Proposed Revisions to a Standard Plans Index

Index Number: 700-011

Index Title: Single Column Cantilever Ground Mounted Sign

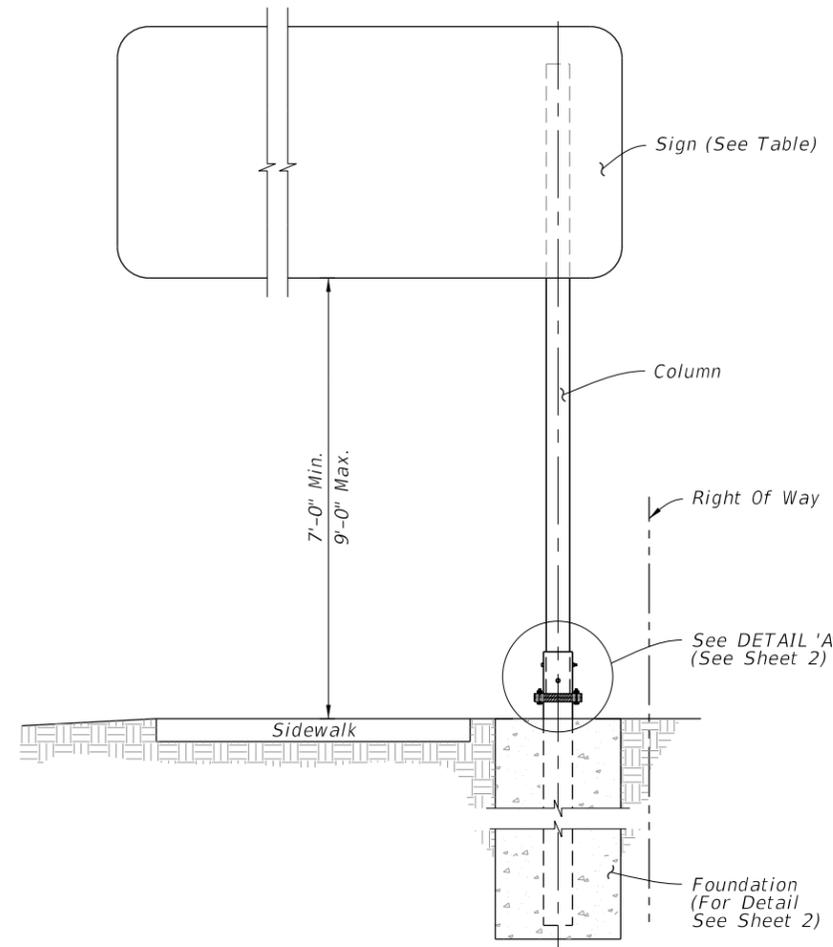
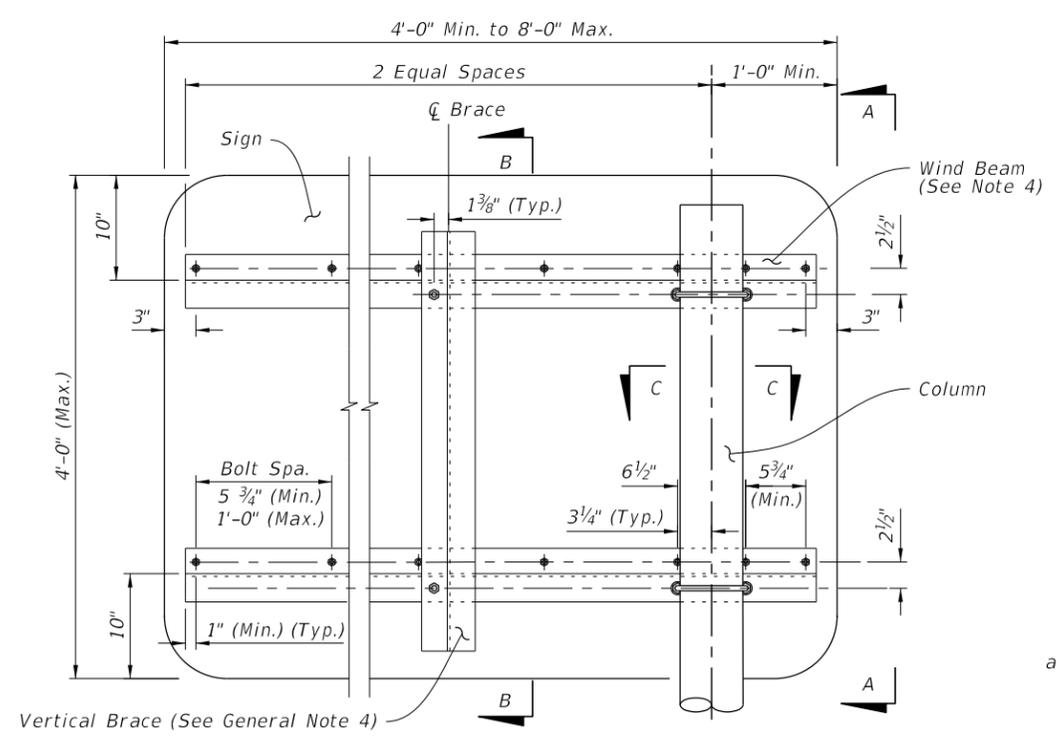
Change the first column to have sign size of Width x Height rather than Height x Length. The for dimensions under the heading will need to be reversed to make this change complete.

The change is to be consistent with how the MUTCD dimensions signs. Section 700 and 995 will also need to be updated to be consistent with MUTCD.

**CHANGED TO:
Width x Height**

- 5'-0" x 4'-0"
- 6'-0" x 4'-0"
- 7'-0" x 4'-0"
- 8'-0" x 4'-0"
